City Council Hearing

CASE NUMBER: ZON18-00214
LOCATION/ADDRESS: The 3100 to 3300 blocks of East Thomas Road (north side).
GENERAL VICINITY: Located on the north side of Thomas Road and west of Val Vista Drive.
REQUEST: Rezoning from AG and RS-43 to RM-2-PAD; and Site Plan Review, also consider the preliminary plat for "Lehi Cove"
PURPOSE: This request will allow for the development of an attached single-residence development
COUNCIL DISTRICT: District 1
OWNER: Arthur L. Freeman Family Trust, Kaser Citrus, Inc., John Babiarz
APPLICANT: Blake McKee, Skybridge Companies
STAFF PLANNER: Evan Balmer, AICP

PROJECT DESCRIPTION/REQUEST

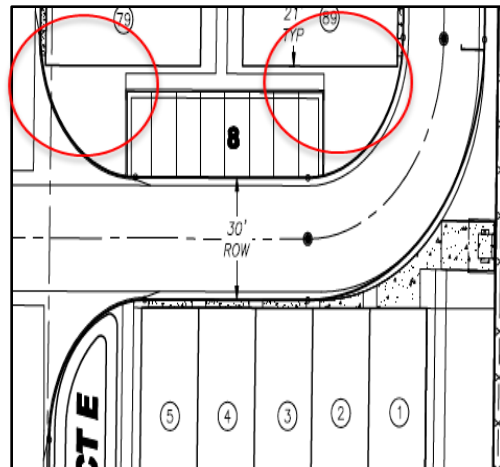
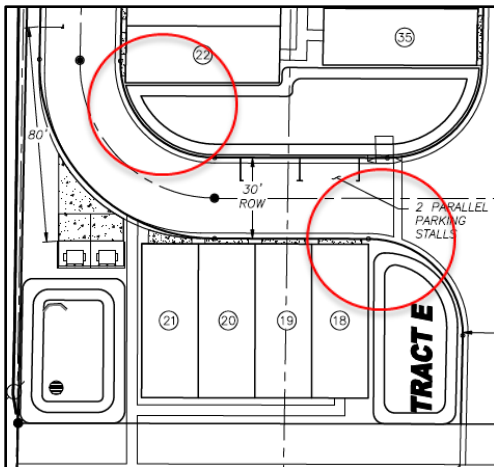
Staff does still have some concerns with the overall design of the project. While the applicant has provided a prominent open space feature for the residents and the buildings feature architectural interest and quality materials, the design itself is still very garage dominant and the primary way residents and guests will experience the development will be through the alleys. Although the property will not be gated, the alleys themselves will be a 30-foot wide private drive. The 30-foot width of the drives allows for additional on-street parking to be provided on the north, east and west sides of the property, but because the internal alleys have garages on both sides, on-street parking would not be allowed in these areas.

In order to create a more inviting experience and add some visual interest to the two internal alleys, staff would recommend adding a speed table and extending the landscaping along the pedestrian connections into the alleys between lots 32 and 33, lots 40 and 41, lots 64 and 65, and lots 74 and 75 as highlighted on the images below:

4. Prior to submitting for a building permit, submit a revised site plan for Planning Director review and acceptance that includes:
 - a. A reduction of the alley to a width of 24' and enhanced landscaping and speed tables between the following lots:

- 32 and 33
 - 40 and 41
 - 64 and 65
 - 74 and 75
 - b. Enhanced pedestrian network from the central open space area to the following areas:
 - Southeast building

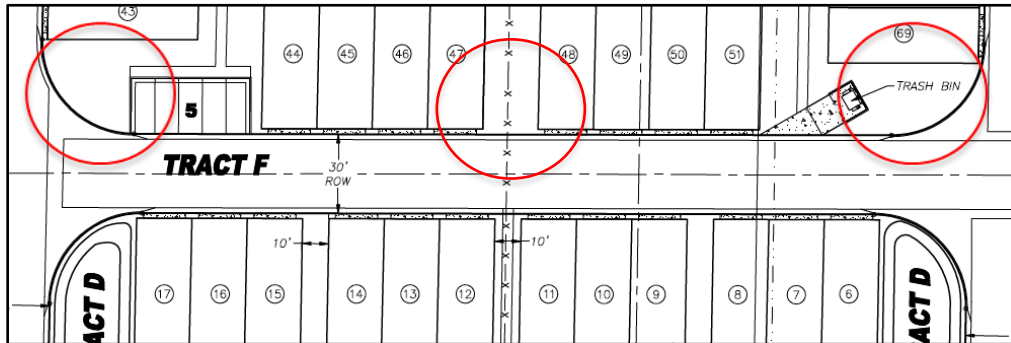
Another area that staff has concerns with is the internal pedestrian connection network. The applicant has included connections to the central amenity area from the east, west and north sides of the development, but there are still some areas of the development where the pedestrian connection is lacking. The southeast and southwest units specifically are only able to access the open space through the street network. Additionally, the parallel parking spaces on the perimeter of the development are lacking access to the sidewalk network. Staff would like to see some additional sidewalks added to

provide a more robust pedestrian network. Some of the areas of concern are highlighted below.

- Southwest building
 - On-street parking locations
5. Compliance with the building elevations and floor plans as submitted.
6. Written notice be provided to future property owners that the project is within a quarter mile of asphalt plant and sand and gravel operations. **[Staff recommended new condition presented at the June 27, 2019 City Council study session].**
